TYPICAL SECTIONS

TYPICAL SECTION  
DANIEL K. INOUE HWY  
Station 304+50 to 311+00  
Arrester Bed, Fill Slope Condition

Amendment A001

3/6/15 Contract negotiation revisions and NPDES compliance

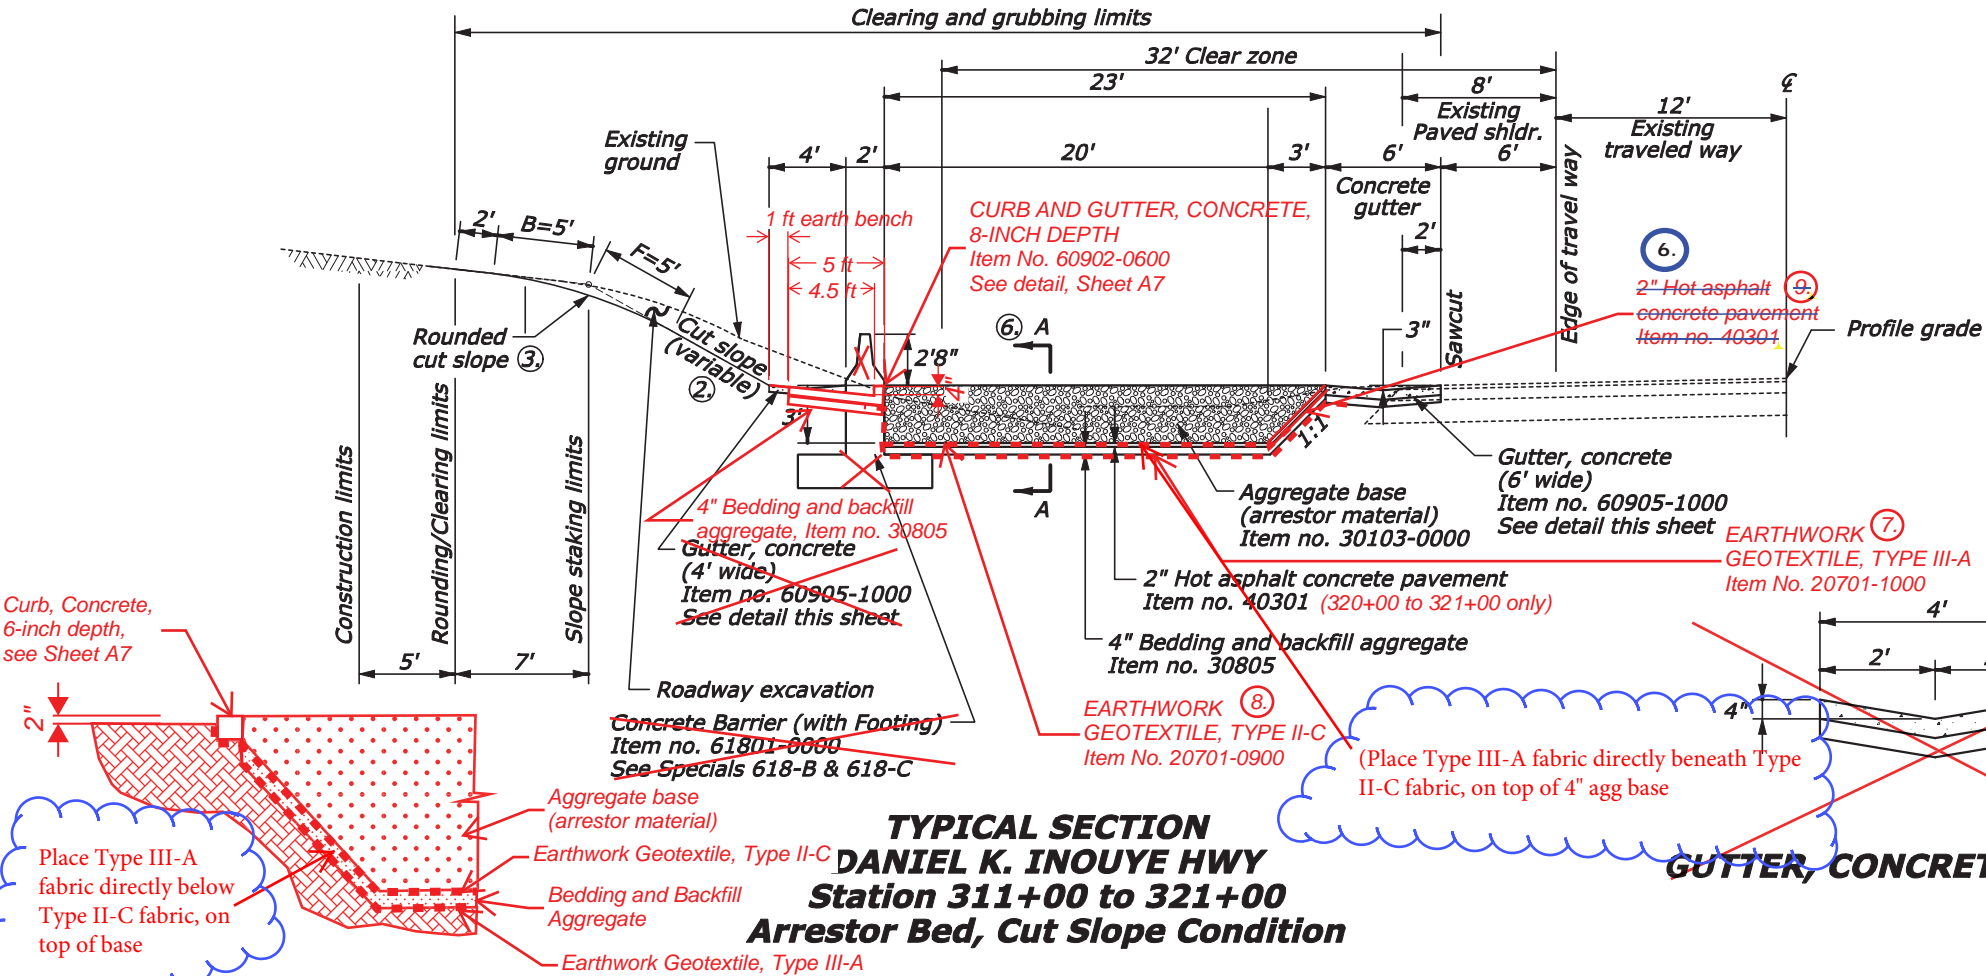
- 8. Geotextile Type II-C, color orange.
- 9. 2" HACP on 1:1 slope, Sta 304+50 Rt to 321+00 Rt.

**TYPICAL SECTION  
DANIEL K. INOUE HWY  
Station 303+50 to 304+50, Station 326+00 to 332+00  
Auxiliary Lane, Fill Slope Condition**

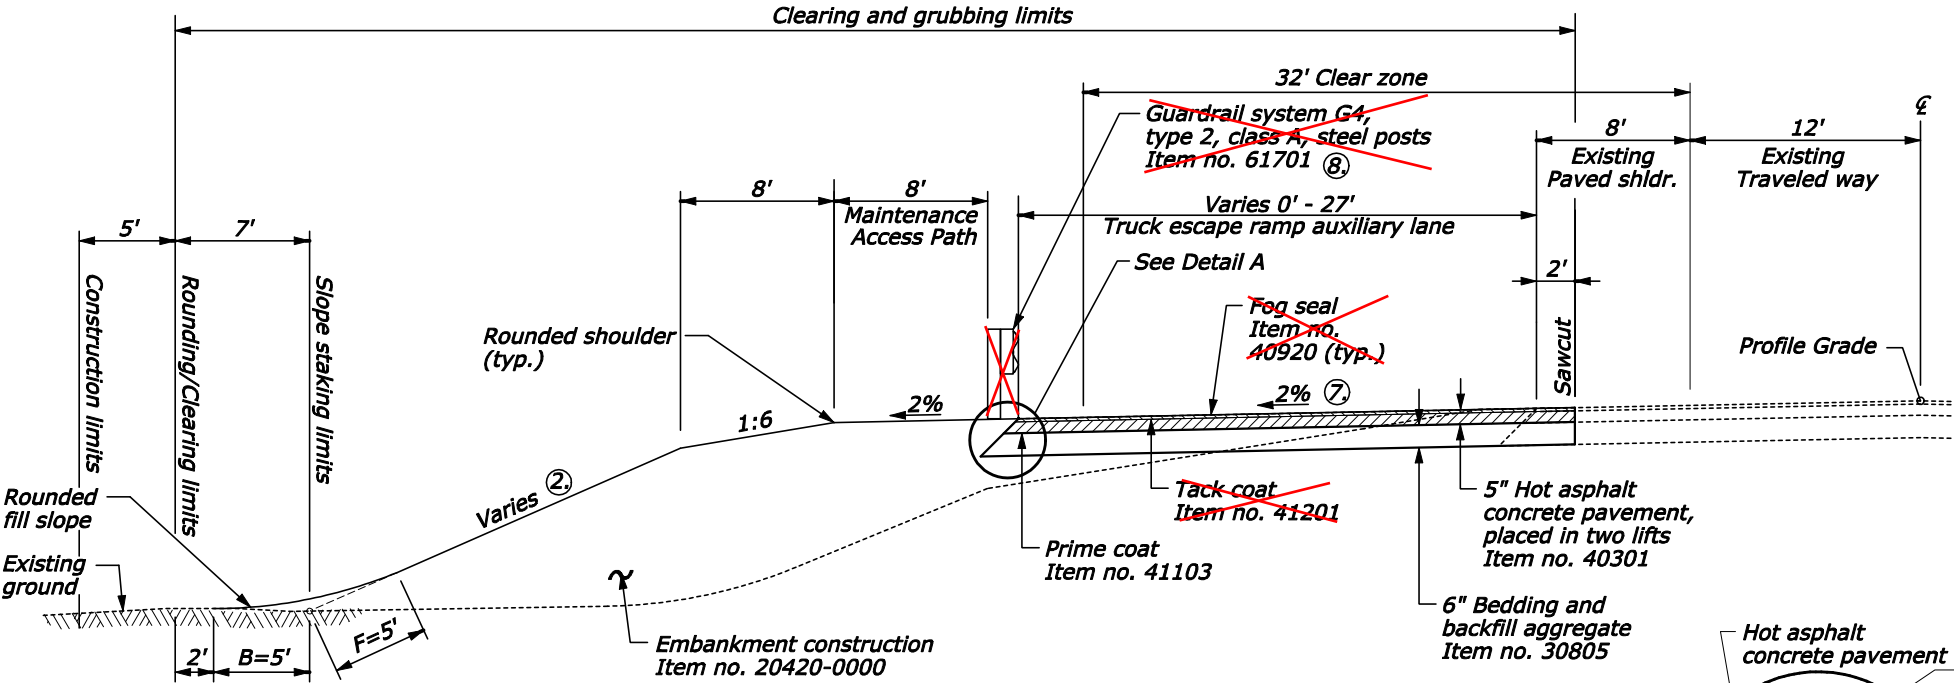
- ① The excavation and embankment slope ratios may be adjusted by the CO to ensure adequate drainage and stability.
- ② See slope ratio table for cut and fill slope ratios. Cut slopes 1:2 and flatter may be steepened one increment if adjusted slope will daylight at or beyond existing top of cut.
- ③ Round all earth slopes and all rippable rock slopes. Reduce the B and F dimensions for cut slope distances less than 9 feet to the actual cut distance.
- ~~4. Apply fog seal to top of hot asphalt concrete pavement finished surface.~~
- 5. See section 204 of the SCR's for finished slope requirements.
- 6. See section 204 and 624 of the SCR's for the placement of topsoil.
- ⑦ 2% minimum. Match existing cross slope on mainline.
- ~~⑧ See plan and profile sheets for guardrail station ranges.~~
